CARRIAGE MEADOWS SOUTH FILING NO.2

A PLANNED UNIT DEVELOPMENT & PRELIMINARY PLAN FOR CARRIAGE MEADOWS SOUTH AT LORSON RANCH FILING 2

PCD FILE NO.: PUDSP-19-05

PUD V_4 Planning Only Review 4.pdf Markup Summary

PUD
SITE PLAN
P6 OF 11

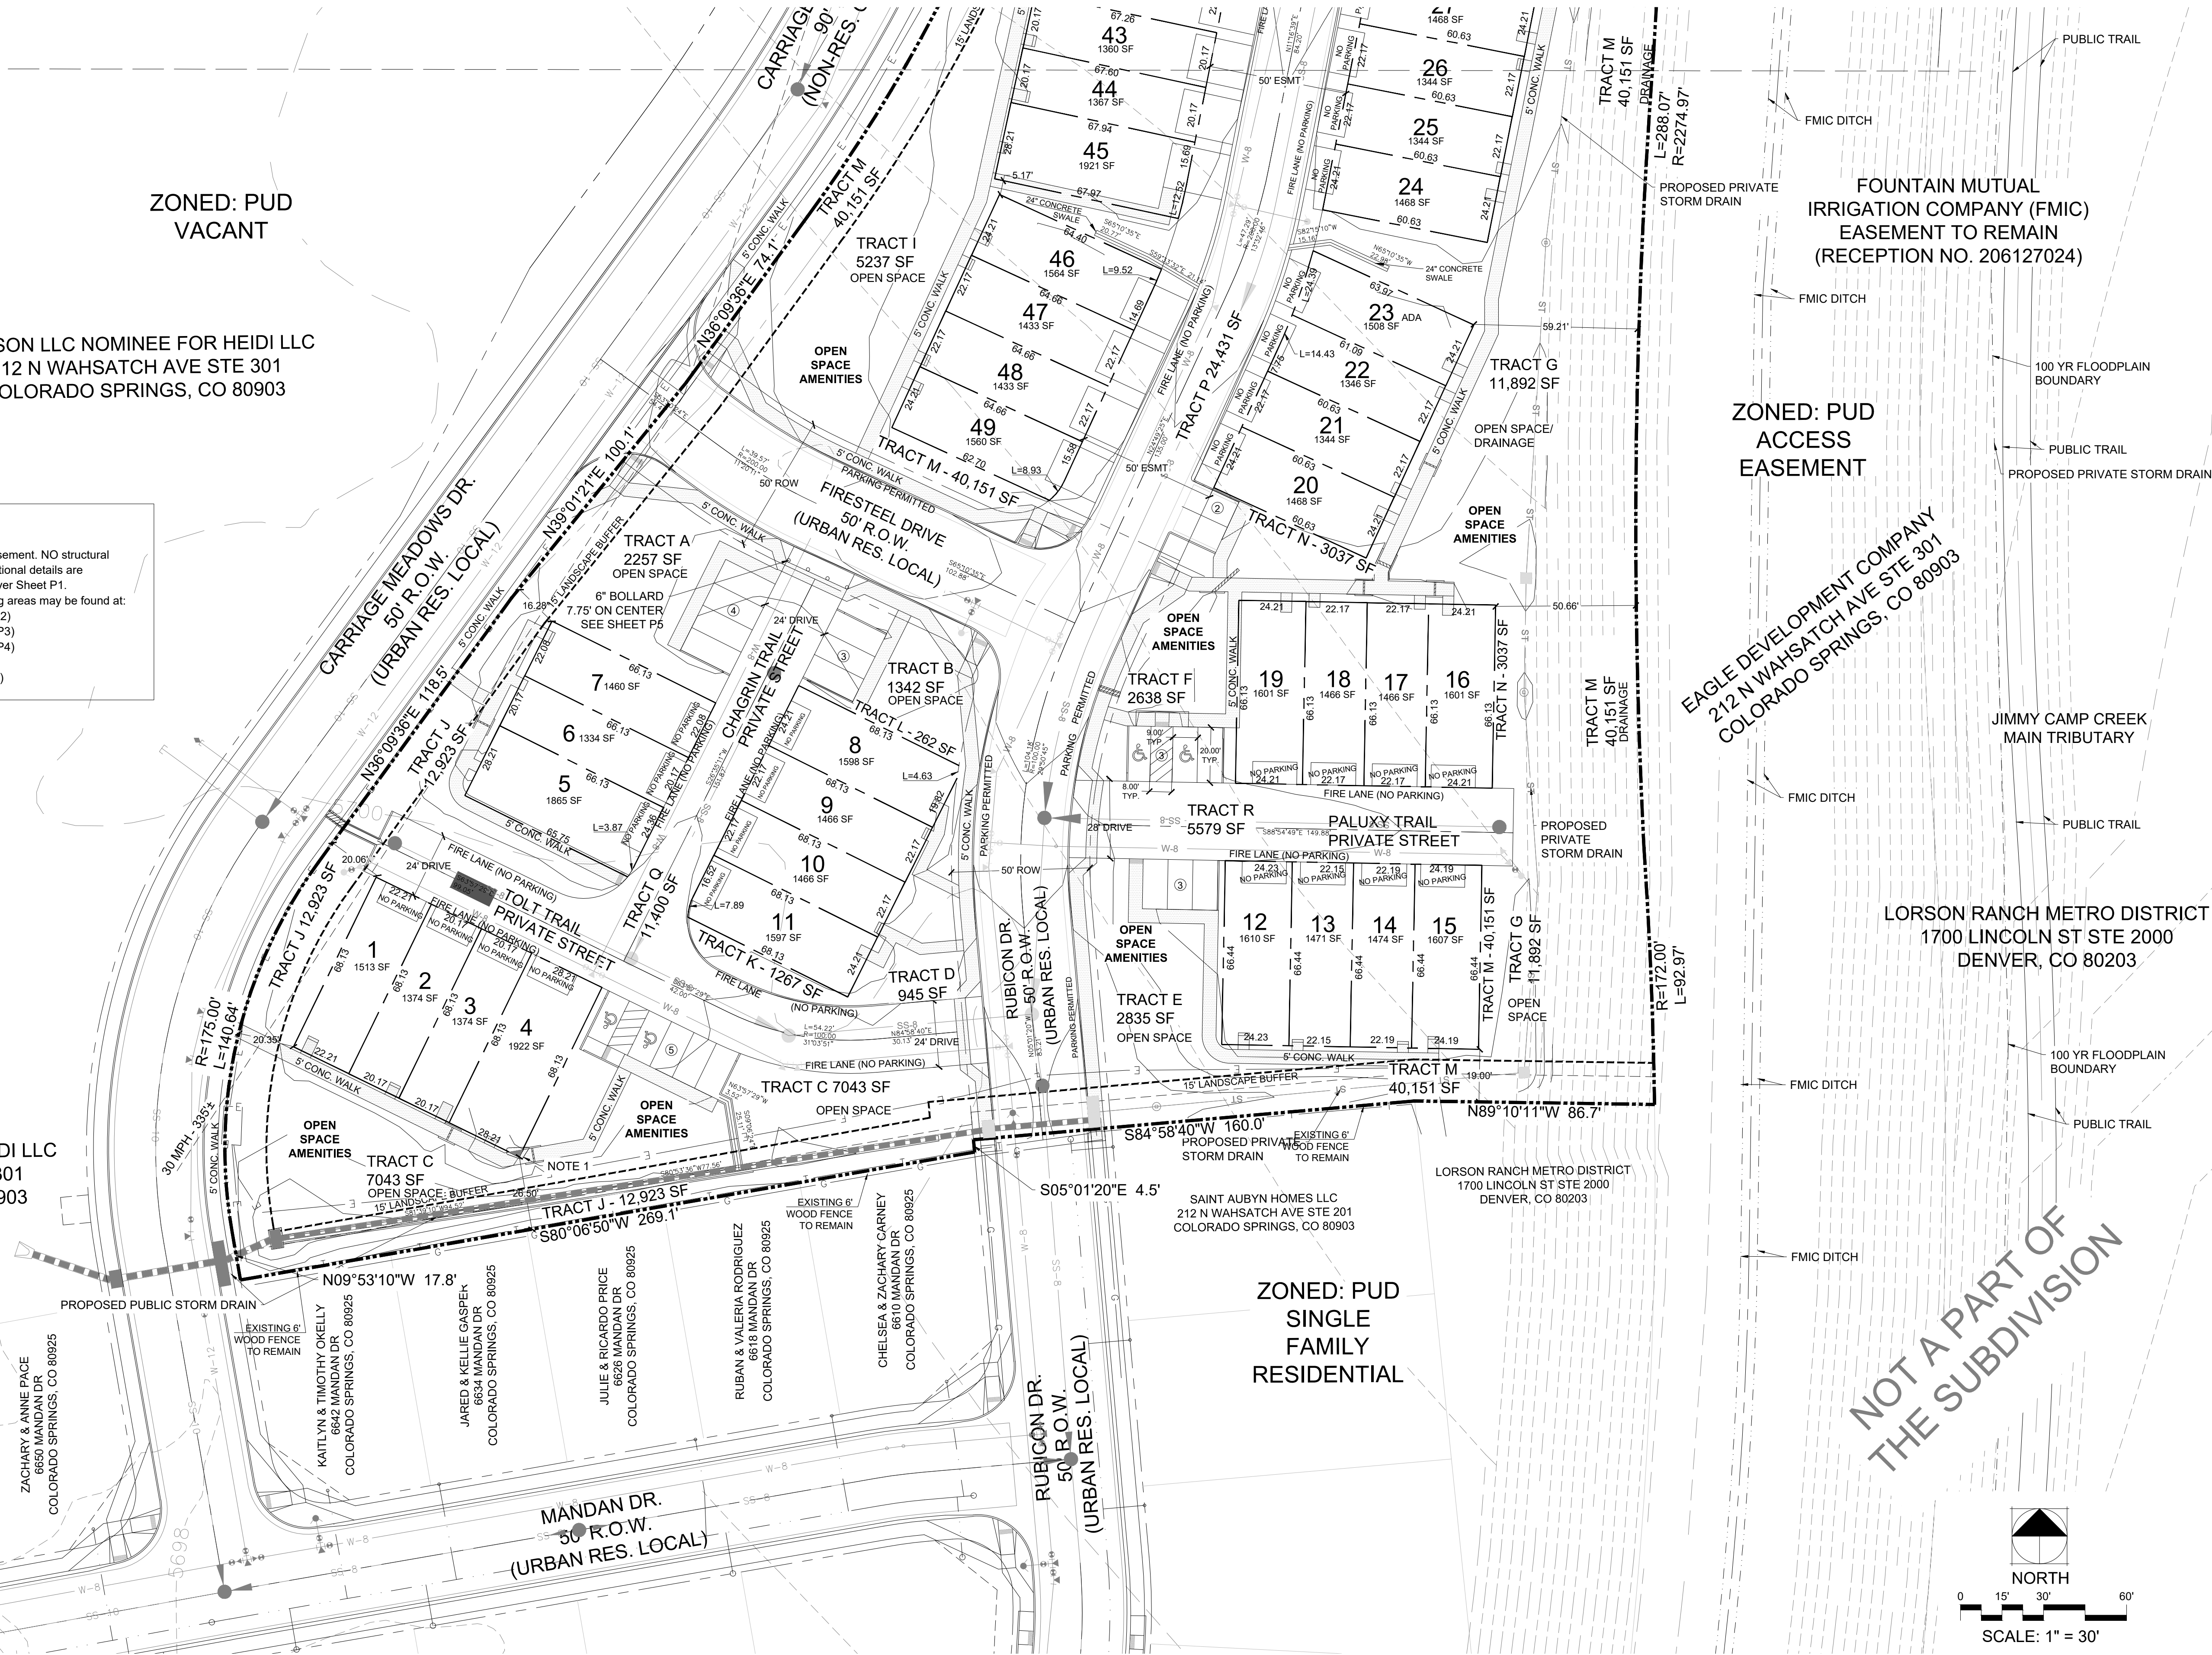
This must be legible after recorded the PUD Font size
Applies throughout

Applies throughout

This must be legible after recorded the PUD Font size
